Office Action Summary

10/519,736

VERTONI, GIOVANNI

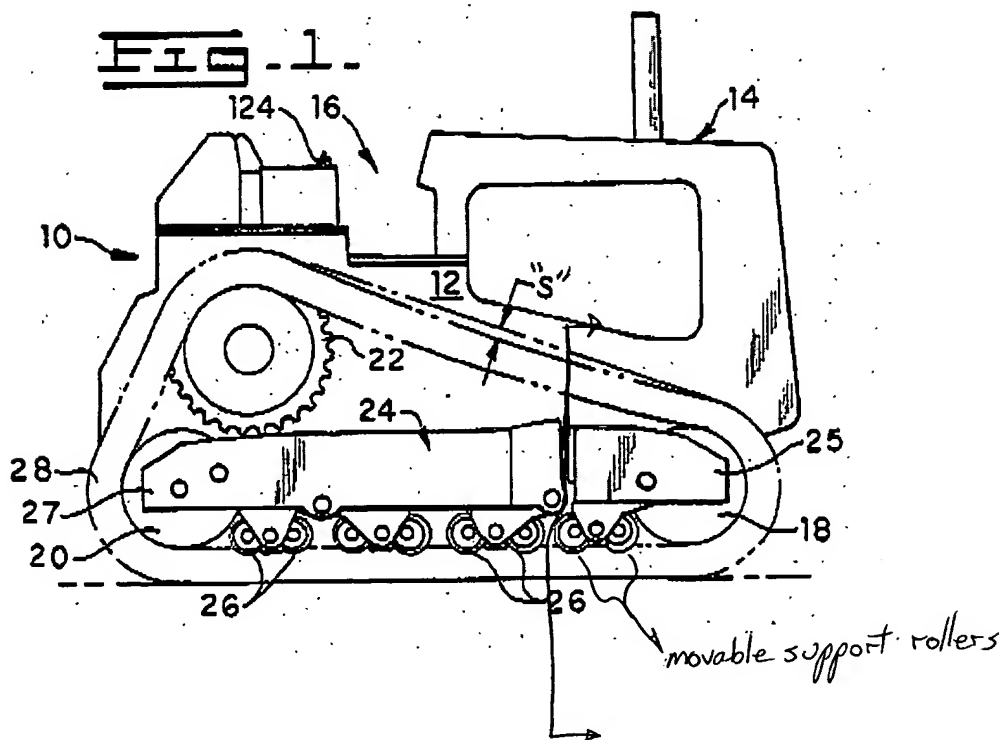
7. Claims 1-2, 4-5, and 7-10 are rejected under 35 U.S.C. 102(b) as being anticipated by Adams et al. As best understood, Adams et al shows a track-tightening device for a crawler assembly. An undercarriage or bogie structure 24 includes elements for carrying a plurality of fixed lower supporting rollers 26, and an idler "back-pull" wheel 20. The structure 24 includes a housing guide system (namely the interaction of the structure 24 and the recoil assembly 30 as shown in Figure 2) for controlled axial sliding of the track-tightening device 30, which is carried by a second

movable structure 25. The structure 24 is box shaped. The second movable structure 25 includes fittings (namely the walls of cylinder 36) to interconnect with the guide system. The second movable structure 25 includes an idler wheel 18 and at least one movable supporting roller (unlabelled), and movably interacts with the structure 24 to modify the wheelbase between the idler wheel 18 and idler "pull-back" wheel 20 through axial sliding.

The Applicant argues that Adams et al lacks a movable support roller that moves longitudinally with the idler wheel. As shown below, a set of supporting rollers is mounted with the idler wheel 18 on the first end portion 25. Therefore, these supporting rollers would be capable of following the longitudinal movement of the idler wheel 18, and the distance between the supporting rollers and the idler wheel 18 would be constant.
